ADDENDUM NUMBER 02 (REVISED)

DATE: January 23, 2024

PROJECT: Cass District Library Edwardsburg, MI

PROJECT NUMBER: 22-1836

A7.3

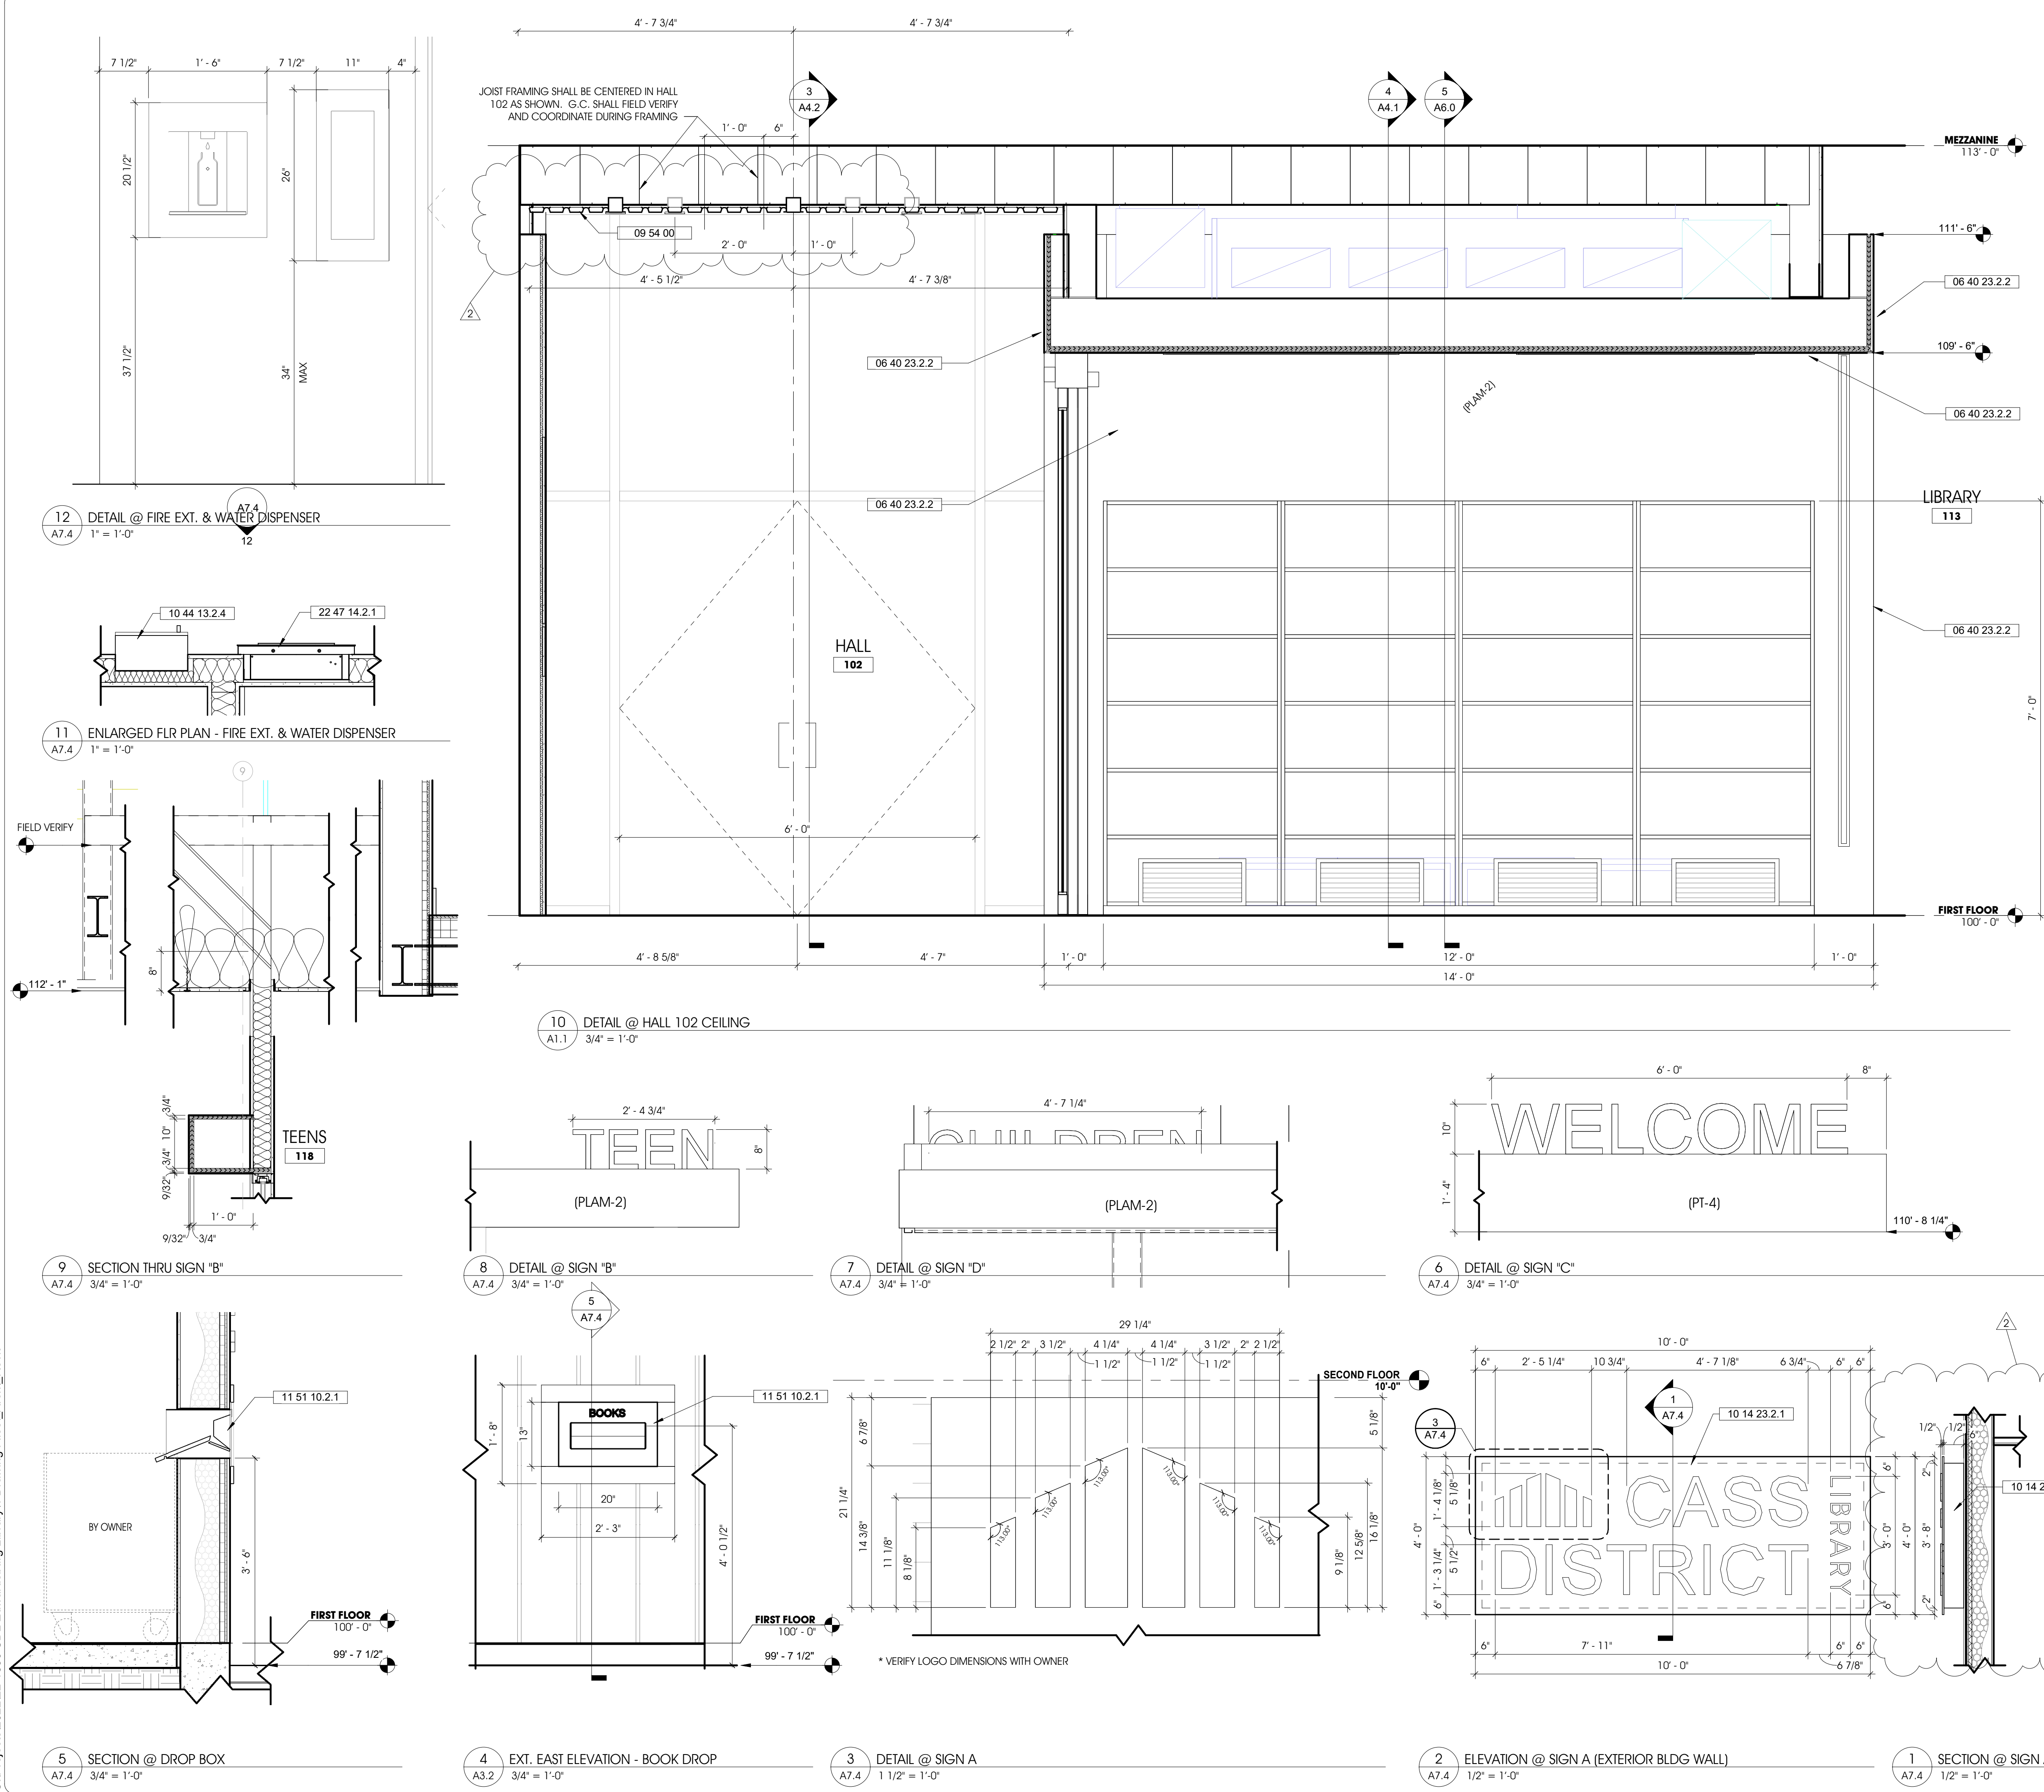
DRAWING A7.3 – SECTION DETAILS (Re-Issued)

- 46. REVISE** Detail #1 – T1-11 boards to be fastened to (2) 2x4 blocking @ 16” o.c. and fastened with #10 Tek screws.

1 FIRST FLOOR FINISH PLAN  
A8.1 1/8" = 1'-0"

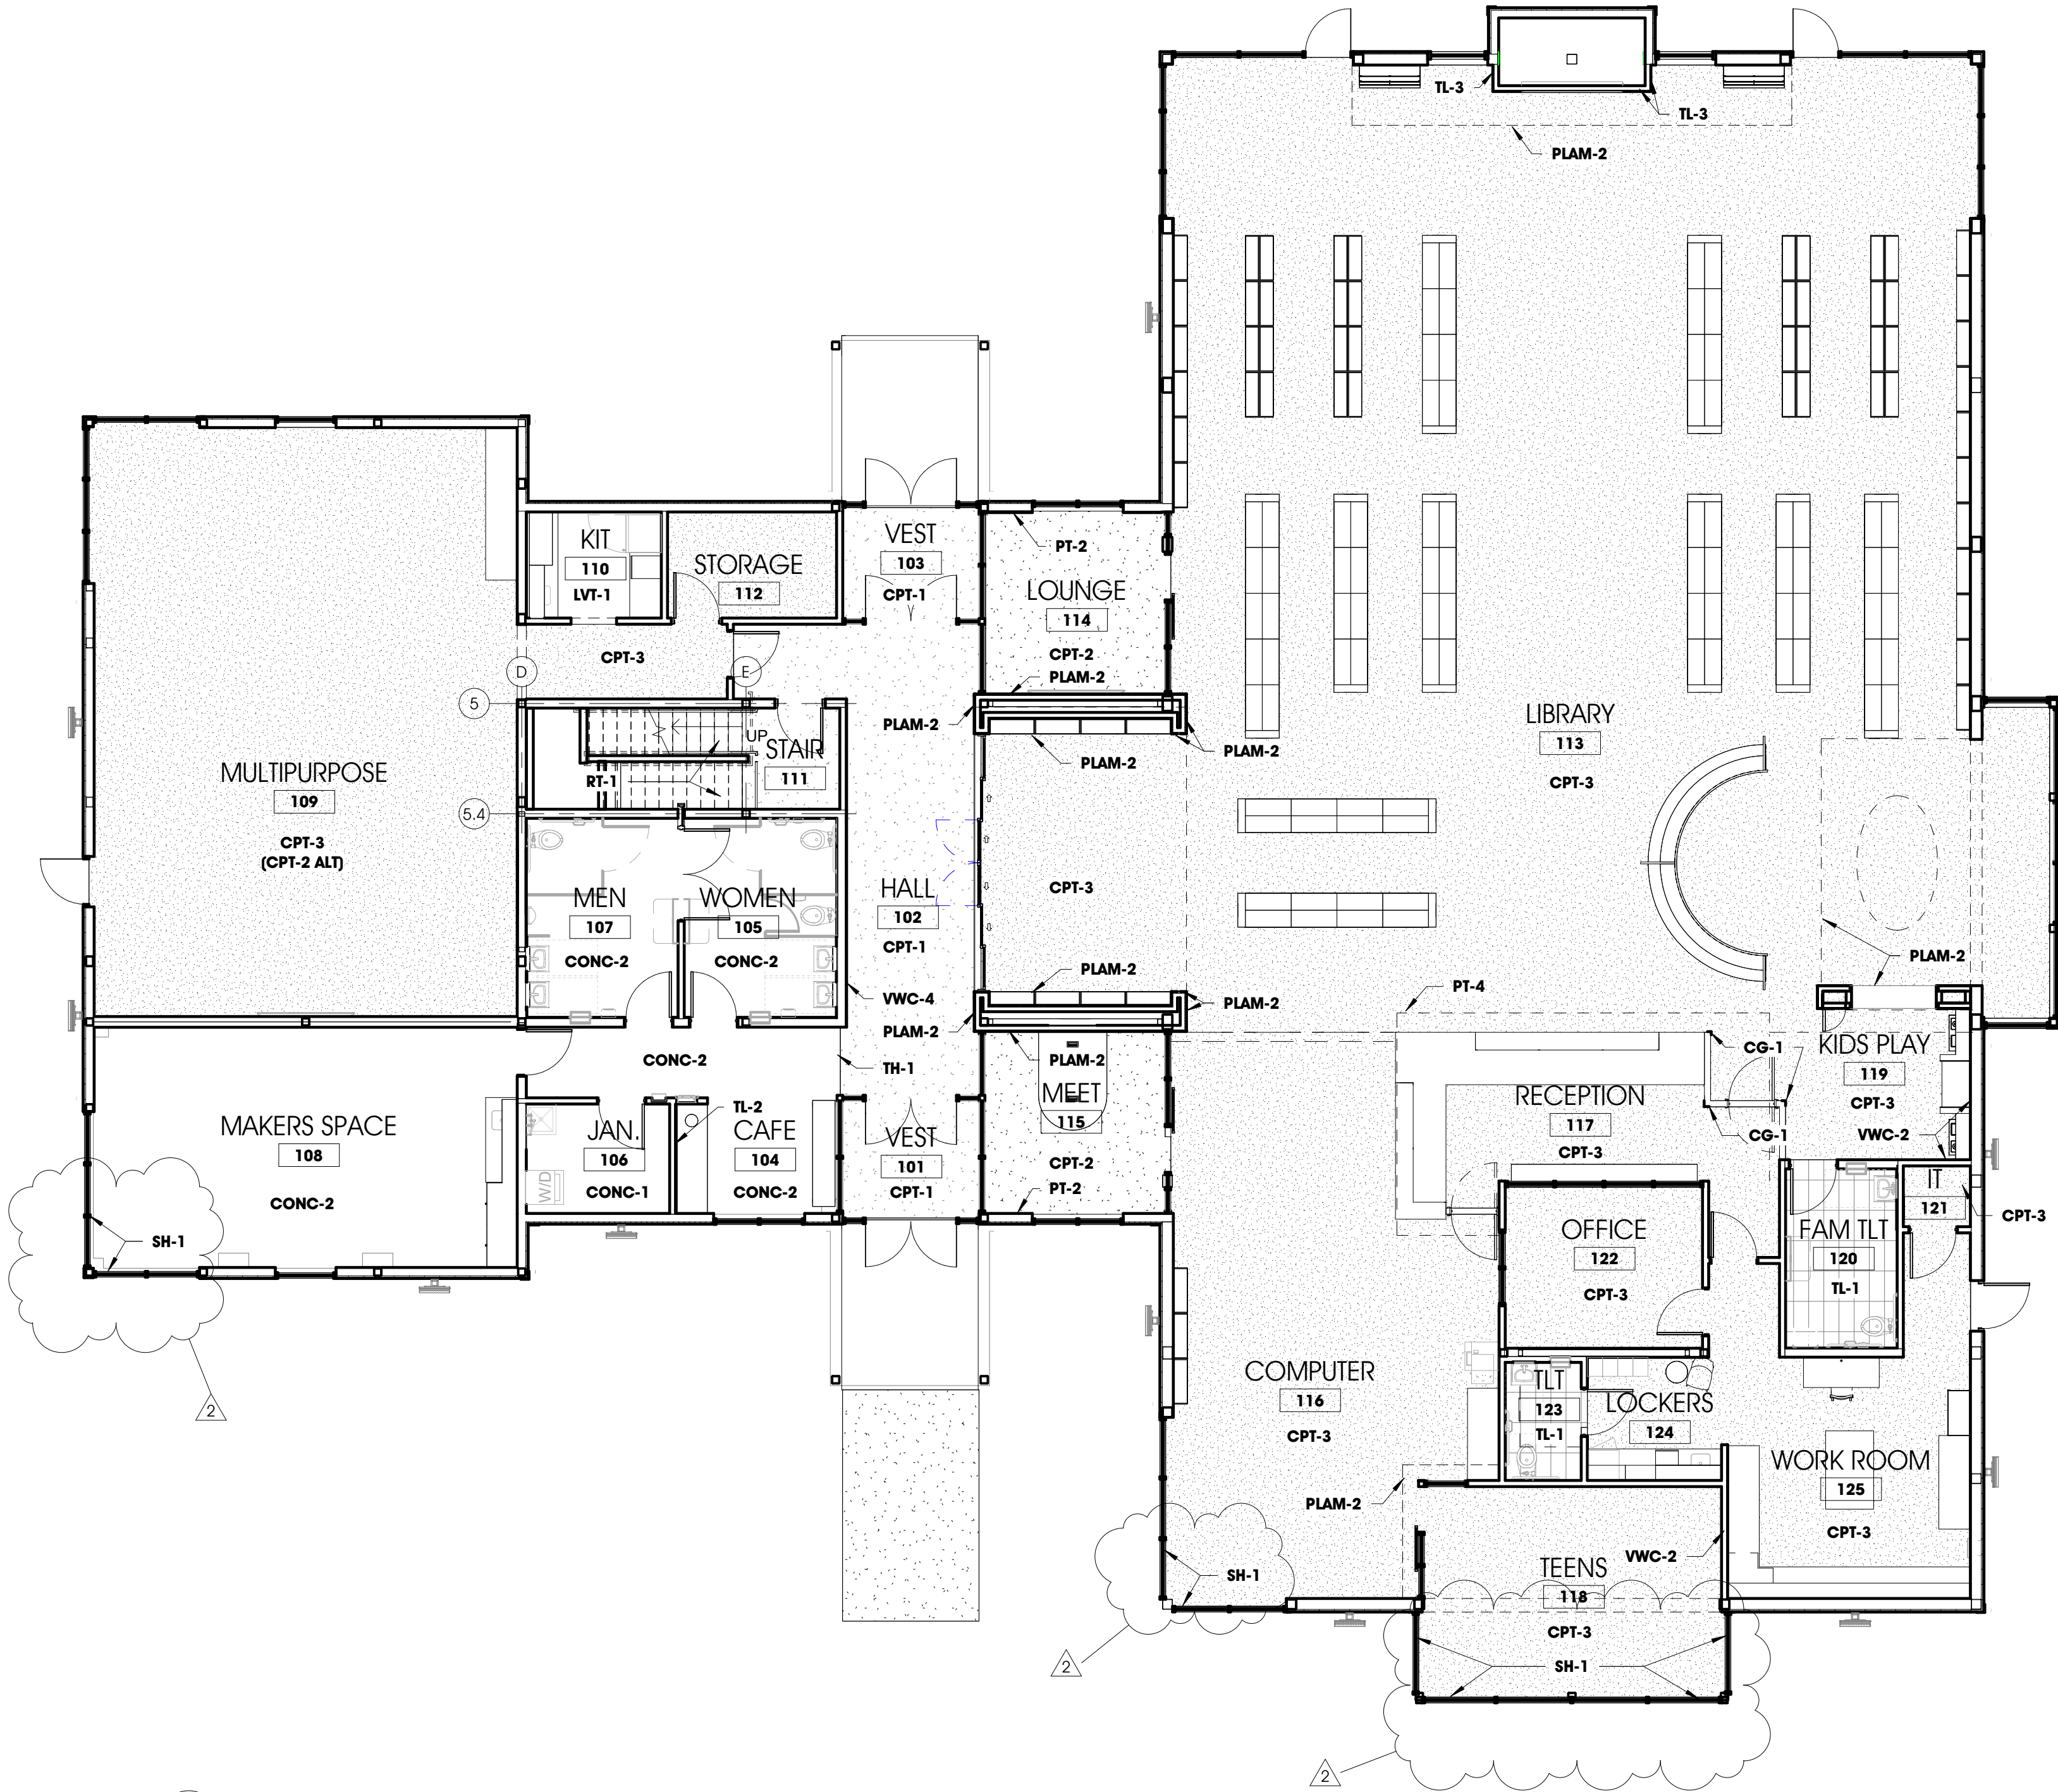
DRAWING A8.1 – ROOM FINISH SCHEDULE AND LEGEND (Re-Issued)

48. **REVISE** No base required at vestibule 101 & 103.  
49. **REVISE** Janitor's closet to have conc-1 finish – See revised room finish schedule  
50. **ADD** New locations designated for roller shades at storefront -  
See revised room finish plan.

- a. Refer to revised first floor finish plan on re-issued sheet A8.1 room finish schedule and legend for roller window shade locations.
- 104. We thought we heard that prevailing wage was going to be waived at the pre-bid meeting. Is this correct?
